Interactive comment on “Investigation of saline water intrusions into the Curonian Lagoon (Lithuania) and two-layer flow in the Klaipėda Strait using finite element hydrodynamic model” by P. Zemlys et al.

Received and published: 22 May 2013

Fig. 1. Revised figure 1

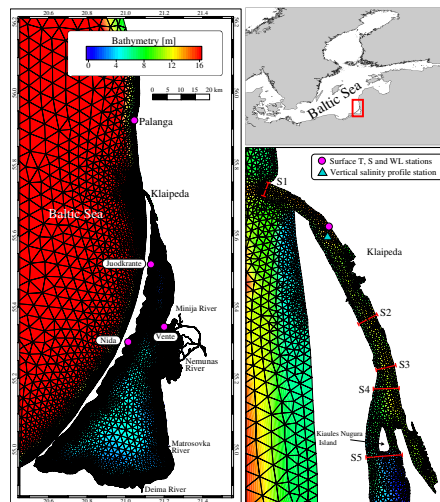
Comment: Figure 1 caption. Is the "surface salinity continuous monitoring station" Klaipeda harbour as referred to in the text?

Comment: Several figures, notably 1, 4, 6 (arrows), 10 (wind rose): electronic versions can be magnified but in print various annotation is presently too small relative to figure size.

Response: "surface salinity continuous monitoring station in Klaipeda harbour" will be written in Figure 1 caption.

Response: The figures will be corrected in final version.
